## Product Change Notice (PCN)

PCN Number: **PCN-0451113R-01**

Product(s) Affected: *PJ-018H*

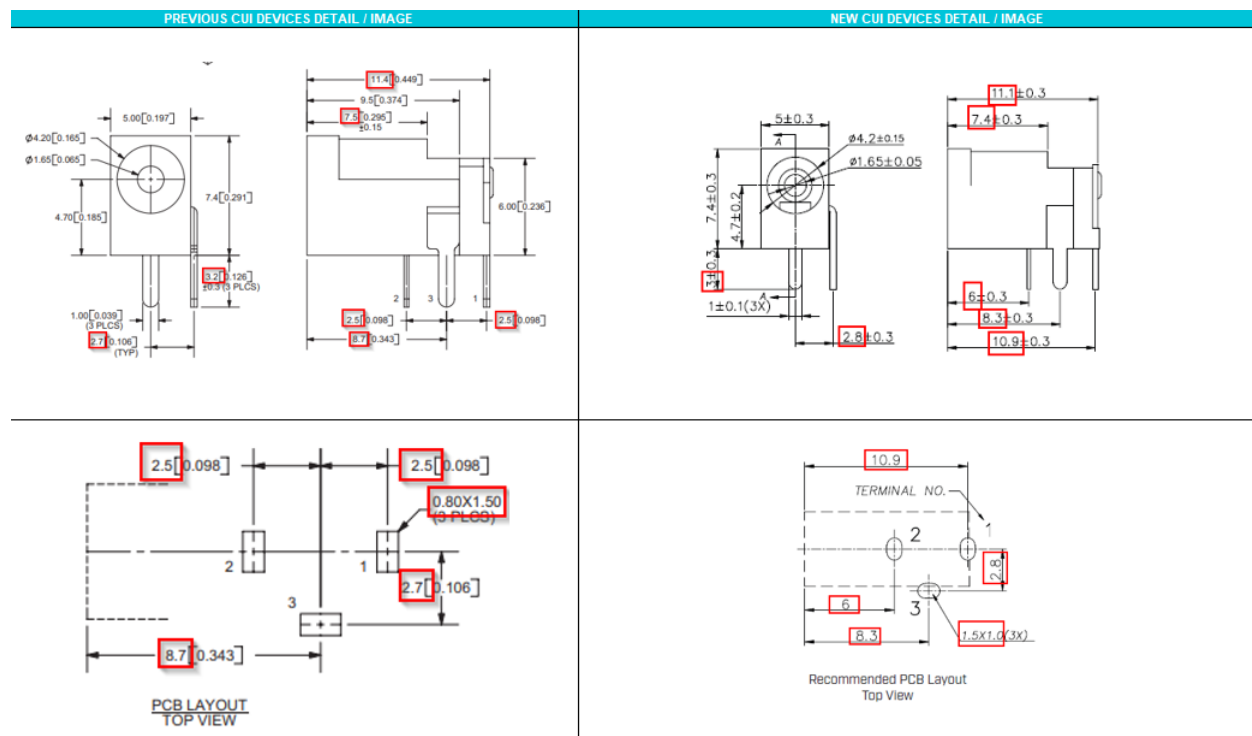
Description of Change: *Minor Housing and footprint differences. Material Change on the housing and terminals. See image Below*

PREVIOUS CUI DEVICES DETAIL / IMAGE	NEW CUI DEVICES DETAIL / IMAGE																																				
 <p>MATING PLUG Jack Insertion Depth: <b>6.6 mm</b></p>	 <p>MATING PLUG Jack Insertion Depth: <b>6.1 mm</b></p>																																				
<table border="1"> <thead> <tr> <th></th> <th>MATERIAL</th> <th>PLATING</th> </tr> </thead> <tbody> <tr> <td>center pin</td> <td><b>copper</b></td> <td><b>nickel</b></td> </tr> <tr> <td>terminal 1</td> <td>brass</td> <td>silver</td> </tr> <tr> <td>terminal 2</td> <td><b>copper alloy</b></td> <td>silver</td> </tr> <tr> <td>terminal 3</td> <td>brass</td> <td>silver</td> </tr> <tr> <td>plastic</td> <td><b>PBT</b></td> <td></td> </tr> </tbody> </table>		MATERIAL	PLATING	center pin	<b>copper</b>	<b>nickel</b>	terminal 1	brass	silver	terminal 2	<b>copper alloy</b>	silver	terminal 3	brass	silver	plastic	<b>PBT</b>		<table border="1"> <thead> <tr> <th>DESCRIPTION</th> <th>MATERIAL</th> <th>PLATING/COLOR</th> </tr> </thead> <tbody> <tr> <td>center pin</td> <td><b>brass</b></td> <td><b>CuSnNi</b></td> </tr> <tr> <td>terminal 1</td> <td>brass t=0.4</td> <td>silver</td> </tr> <tr> <td>terminal 2</td> <td><b>phosphor bronze</b> t=0.25</td> <td>silver</td> </tr> <tr> <td>terminal 3</td> <td>brass t=0.4</td> <td>silver</td> </tr> <tr> <td>housing</td> <td><b>PA10T</b> [UL94V-0]</td> <td>black</td> </tr> </tbody> </table>	DESCRIPTION	MATERIAL	PLATING/COLOR	center pin	<b>brass</b>	<b>CuSnNi</b>	terminal 1	brass t=0.4	silver	terminal 2	<b>phosphor bronze</b> t=0.25	silver	terminal 3	brass t=0.4	silver	housing	<b>PA10T</b> [UL94V-0]	black

MATERIAL	PLATING																																			
center pin	<b>copper</b>	<b>nickel</b>																																			
terminal 1	brass	silver																																			
terminal 2	<b>copper alloy</b>	silver																																			
terminal 3	brass	silver																																			
plastic	<b>PBT</b>																																				
DESCRIPTION	MATERIAL	PLATING/COLOR																																			
center pin	<b>brass</b>	<b>CuSnNi</b>																																			
terminal 1	brass t=0.4	silver																																			
terminal 2	<b>phosphor bronze</b> t=0.25	silver																																			
terminal 3	brass t=0.4	silver																																			
housing	<b>PA10T</b> [UL94V-0]	black																																			
<p><b>SPECIFICATIONS</b></p> <table border="1"> <thead> <tr> <th>parameter</th> <th>conditions/description</th> <th>min</th> <th>typ</th> <th>max</th> <th>units</th> </tr> </thead> <tbody> <tr> <td>rated input voltage</td> <td></td> <td></td> <td><b>10</b></td> <td></td> <td>Vdc</td> </tr> <tr> <td>rated input current</td> <td></td> <td></td> <td></td> <td>3.5</td> <td>A</td> </tr> </tbody> </table>	parameter	conditions/description	min	typ	max	units	rated input voltage			<b>10</b>		Vdc	rated input current				3.5	A	<p><b>SPECIFICATIONS</b></p> <table border="1"> <thead> <tr> <th>parameter</th> <th>conditions/description</th> <th>min</th> <th>typ</th> <th>max</th> <th>units</th> </tr> </thead> <tbody> <tr> <td>rated input voltage</td> <td></td> <td></td> <td><b>24</b></td> <td></td> <td>Vdc</td> </tr> <tr> <td>rated input current</td> <td></td> <td></td> <td></td> <td>3.5</td> <td>A</td> </tr> </tbody> </table>	parameter	conditions/description	min	typ	max	units	rated input voltage			<b>24</b>		Vdc	rated input current				3.5	A

parameter	conditions/description	min	typ	max	units																																
rated input voltage			<b>10</b>		Vdc																																
rated input current				3.5	A																																
parameter	conditions/description	min	typ	max	units																																
rated input voltage			<b>24</b>		Vdc																																
rated input current				3.5	A
